INDIANA DEPARTMENT OF TRANSPORTATION

May 16, 2013 Standards Committee Meeting

RE: Agenda for the May 16, 2013 Standards Committee Meeting

SPECIFICATION, SPECIAL PROVISIONS AND DRAWINGS
REVISION TO STANDARD SPECIFICATIONS

PROPOSED NEW XXX-X-XXX LONGITUDINAL RUMBLE STRIPES

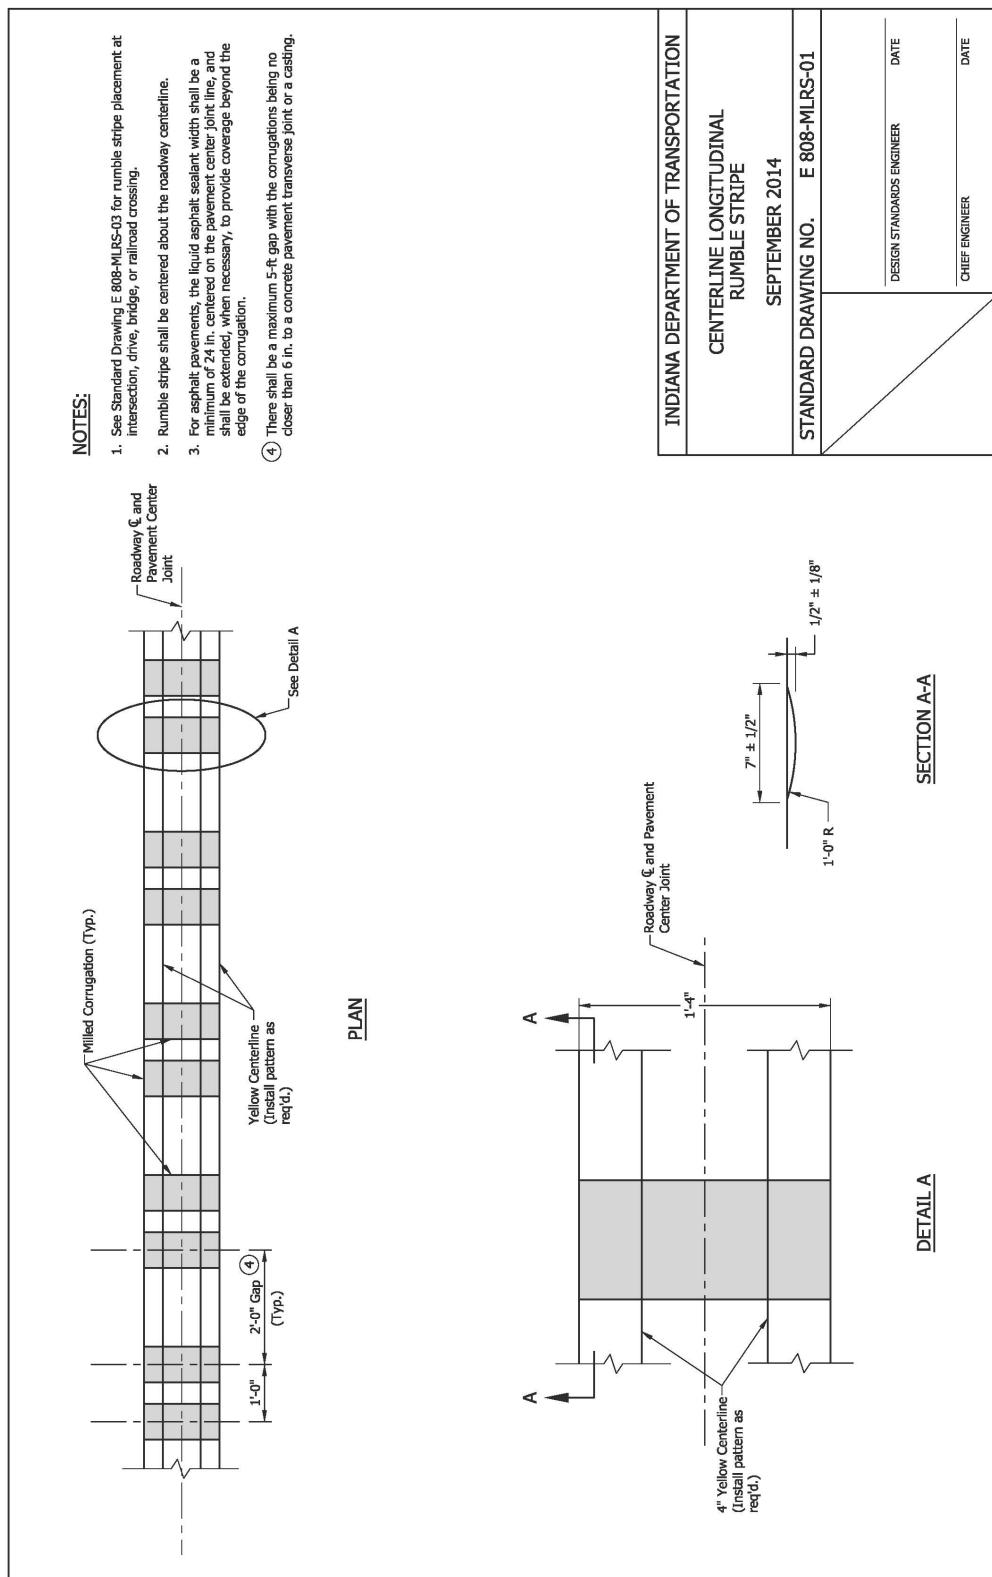
PROPOSED SOLUTION: The proposed specifications and standard drawings will describe and show the proper construction methods for longitudinal rumble stripes. The specs, drawings, and designer guidance represent the best practices in other states and from the test projects under the JTRP study.

Longitudinal rumble stripes are the combination of either the center line pavement marking placed in the center line corrugation or the edge line pavement marking placed in the edge line corrugation. They shall be installed as shown in the plans and as specified herein.

EXISTING RPD 606-R-563d MILLED CENTERLINE CORRUGATIONS (PROPOSED TO DELETE)

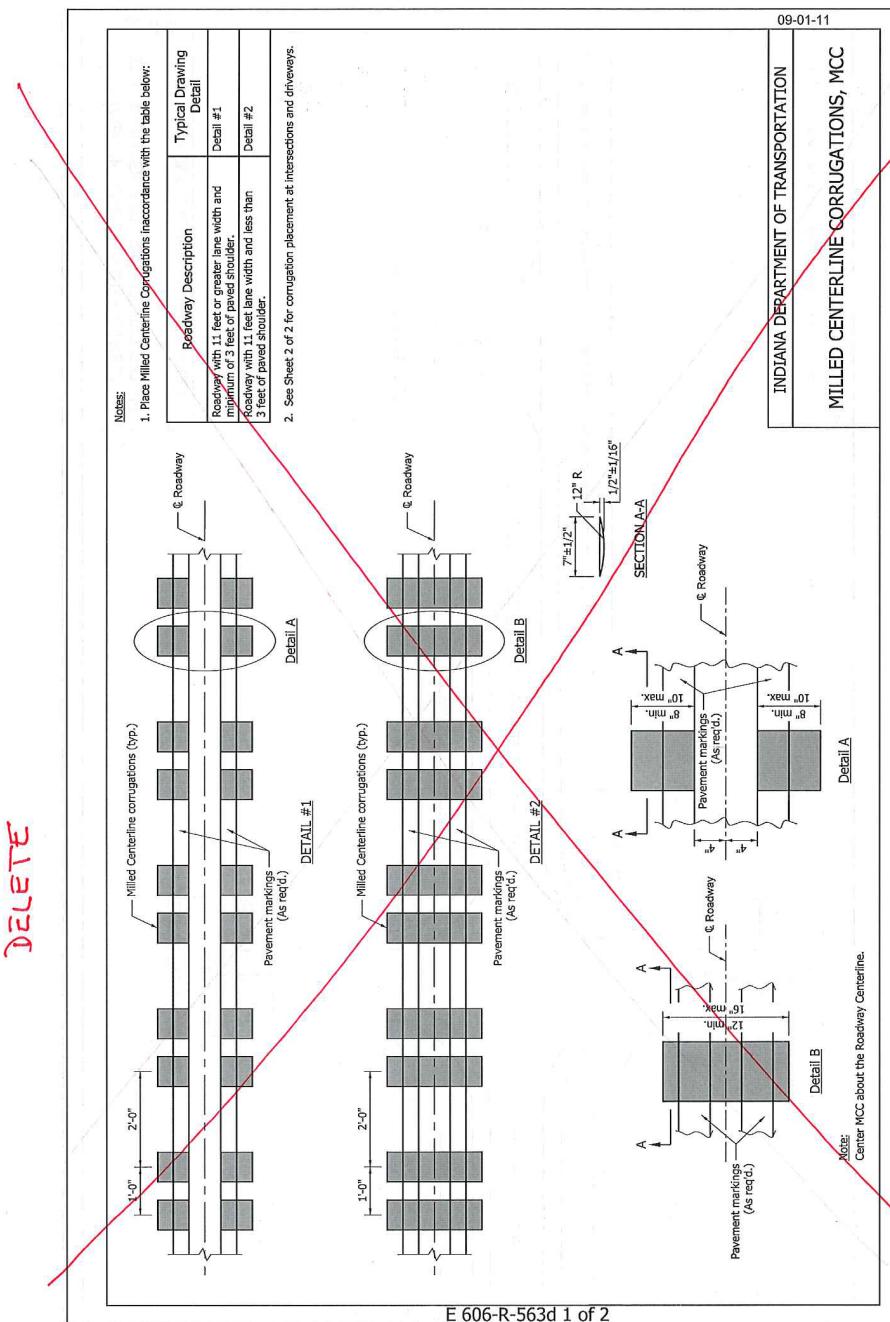
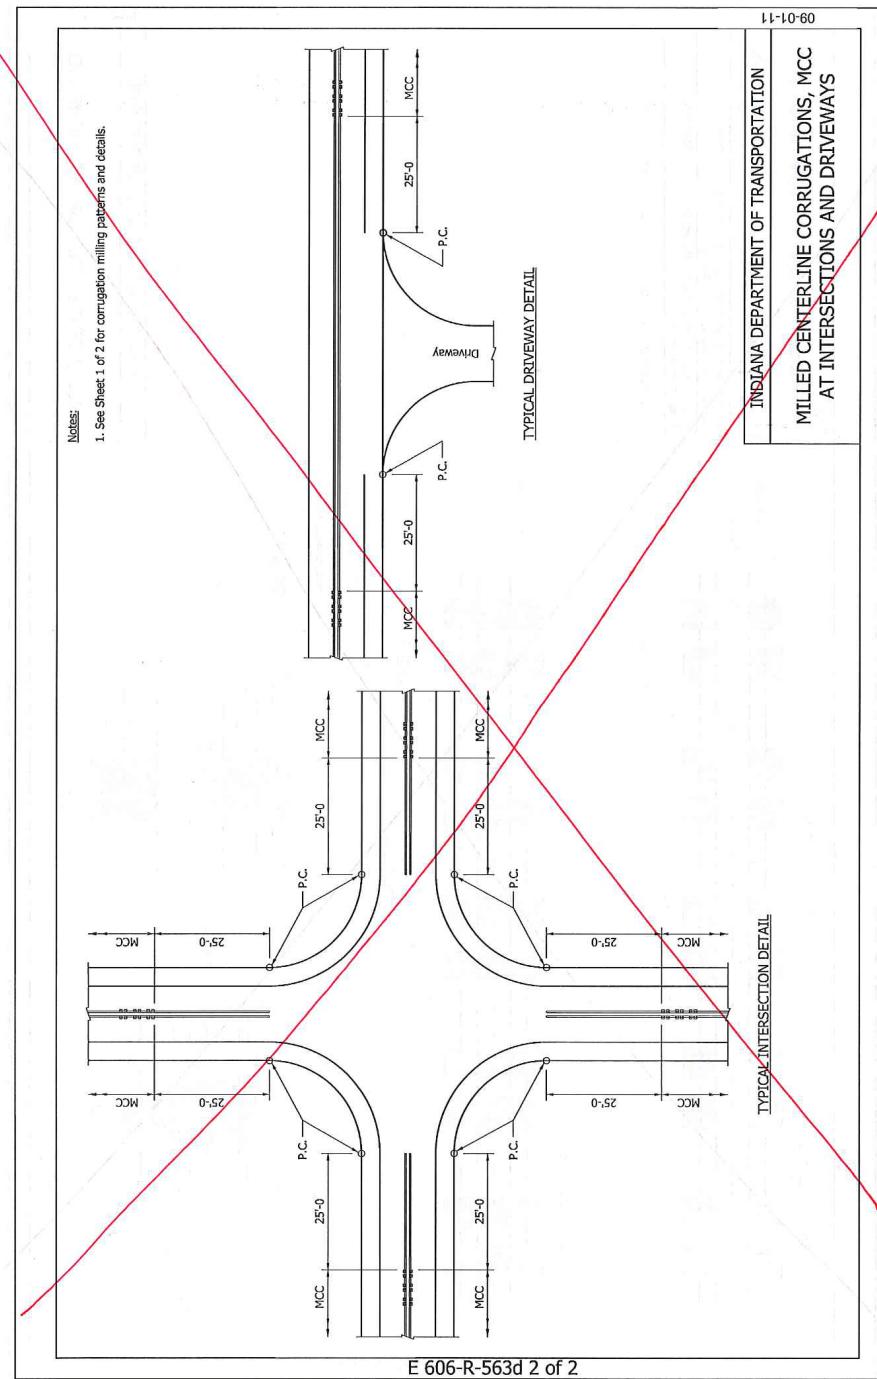
EXISTING RSP 606-R-563 MILLED CENTERLINE CORRUGATIONS (PROPOSED TO
DELETE)

DELETE
